GRACE VALLEY RANCH, PHASE 6

ADDENDUM #2

05/16/2025

C4.02

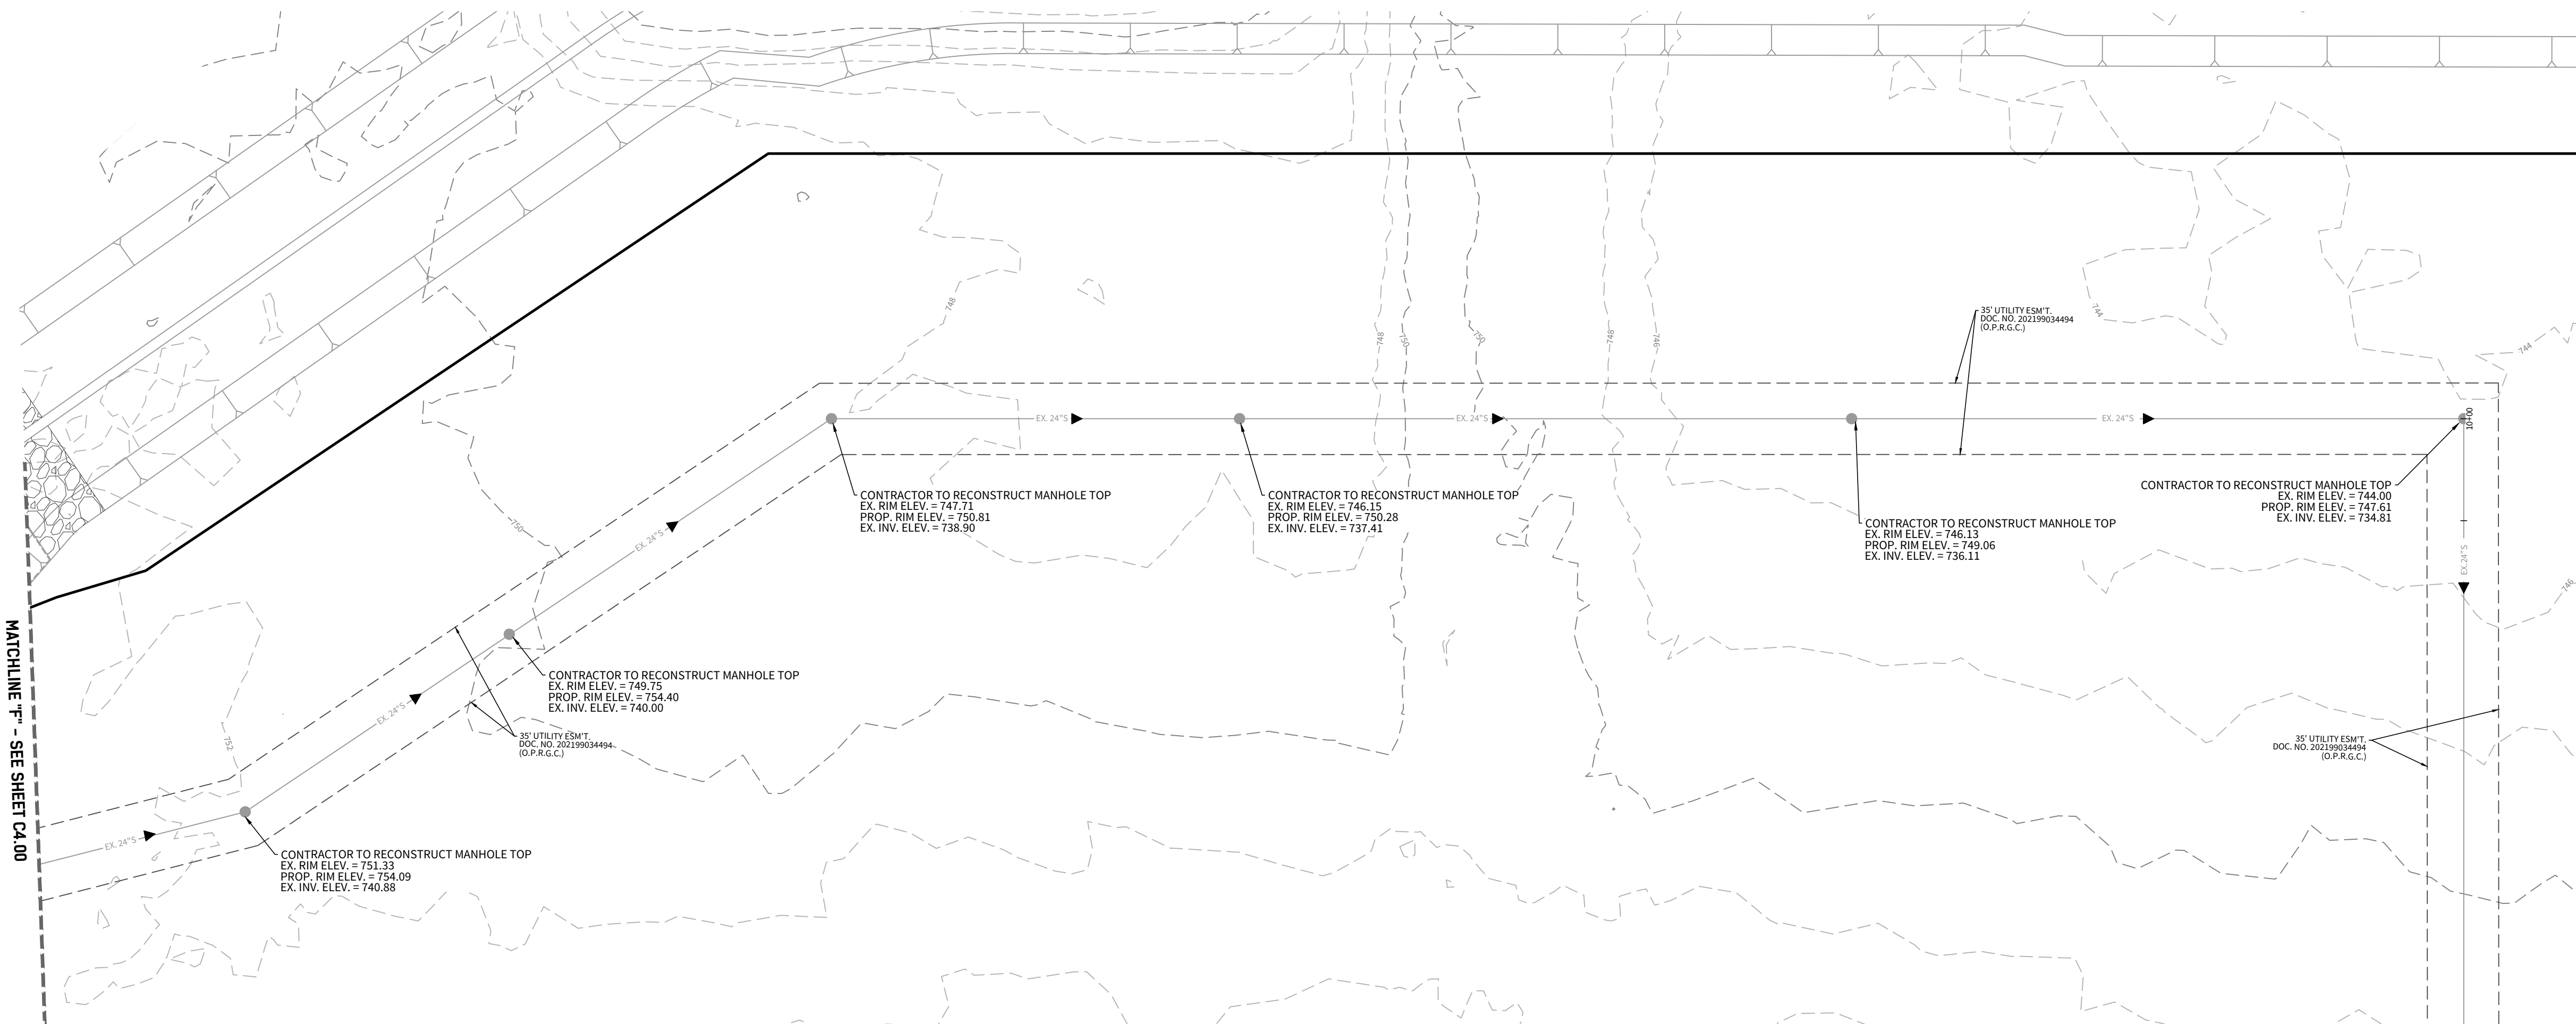
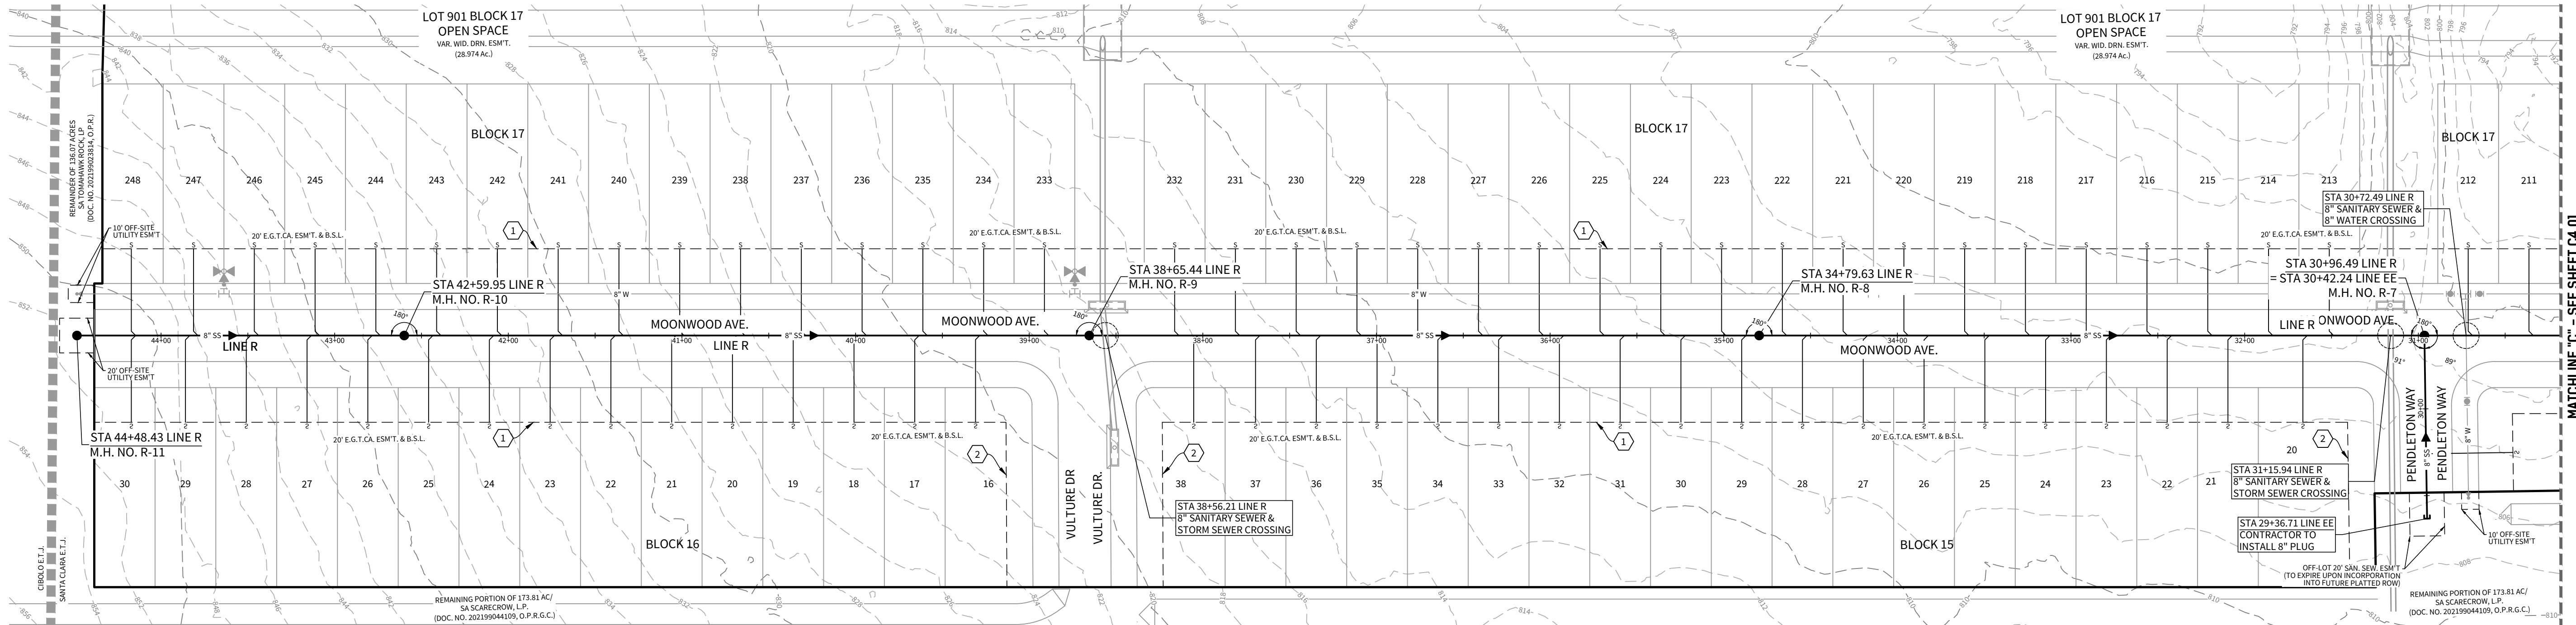
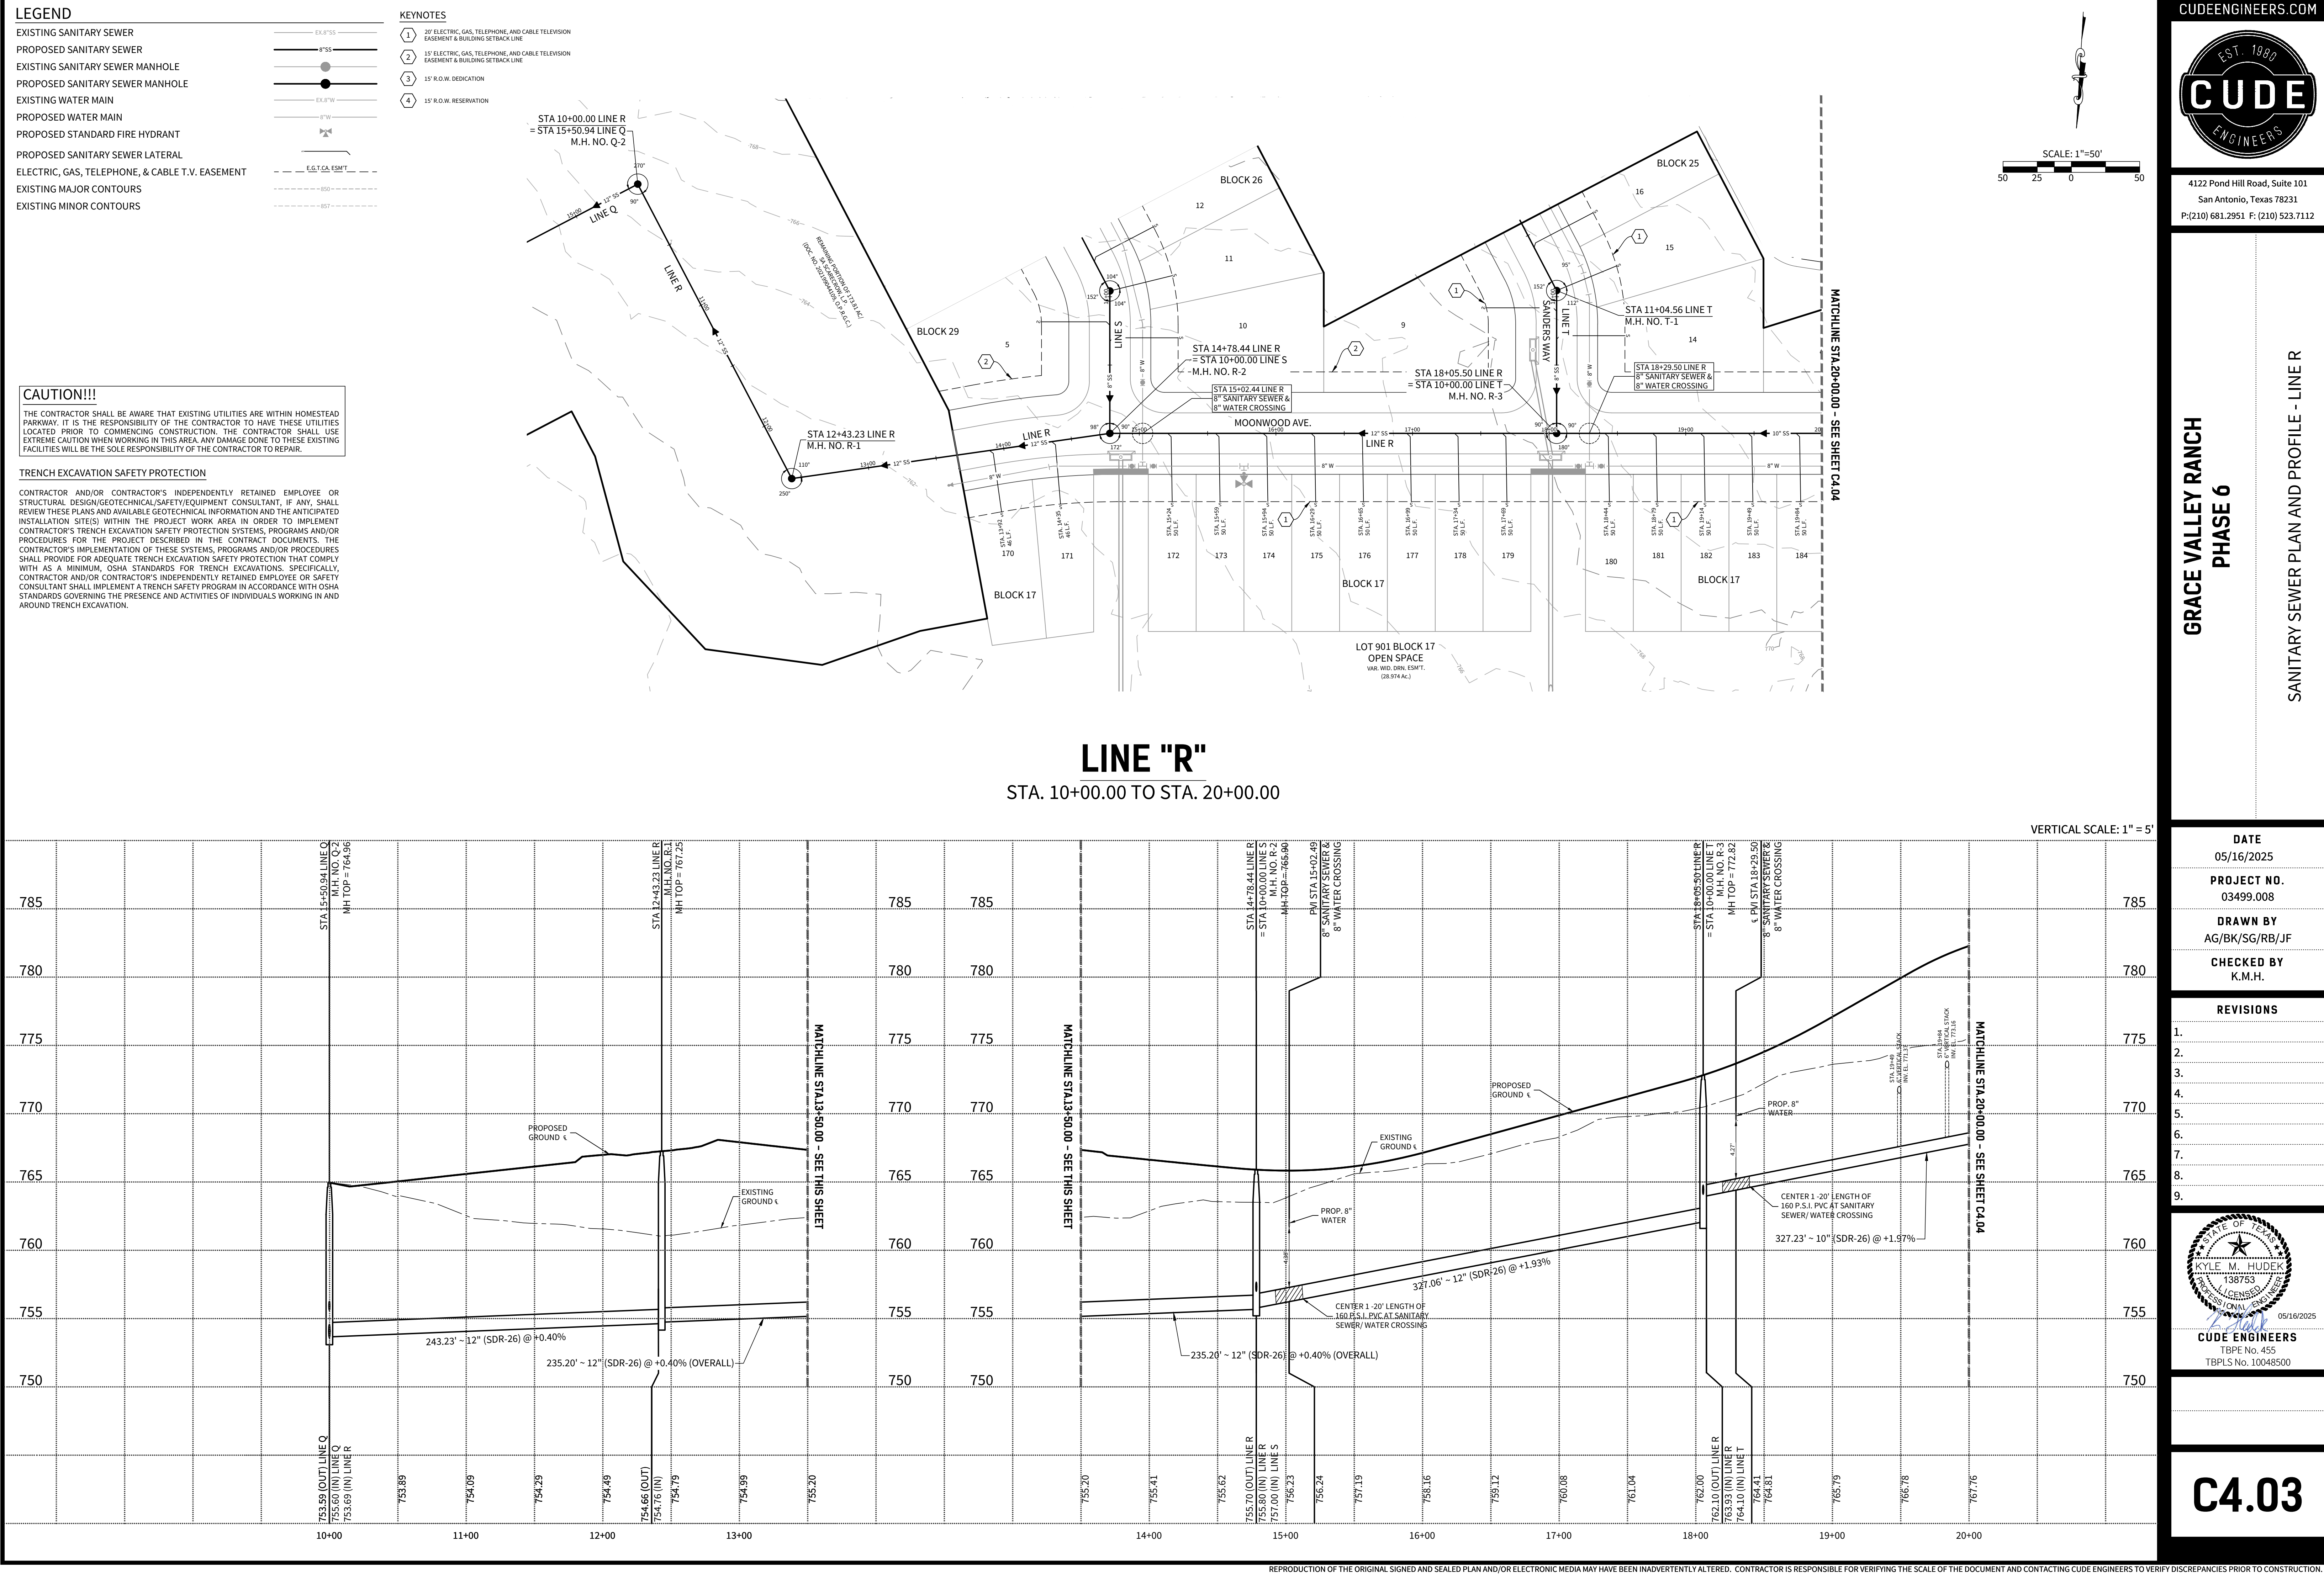
- Question 35** What type of pipe is the existing 6" water main we need to tie into?
- Answer 35** *The existing 6" pipe is PVC.*
-
- Question 36** What are the depths of the 15 existing manholes we are required to reconstruct/adjust, since we need to recoat?

- Answer 36** *The existing manhole inverts have been shown on revised sheets C4.00 and C4.02 included with Addendum #2.*
